APPLICATION NUMBER: 25/0966

PROPOSAL: PROPOSED DEMOLITION OF THE EXISTING SINGLE STOREY SIDE EXTENSION AND THE ERECTION OF A TWO STOREY SIDE EXTENSION

SITE: Holly House Wentwood Road Penhow Newport NP26 3AE

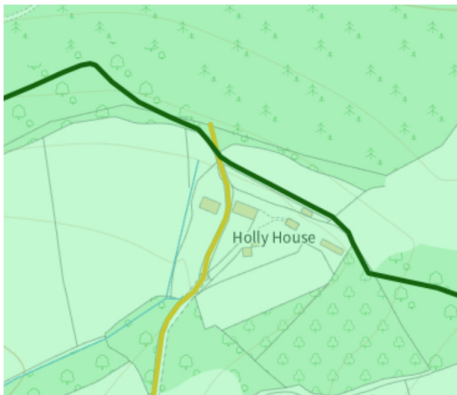
The landscape setting is sensitive, the site is elevated on the open field slopes close to the edge of extensive woodland covering and within the Wentwood Special Landscape Area, in addition the site lies close to rights of way as shown below.
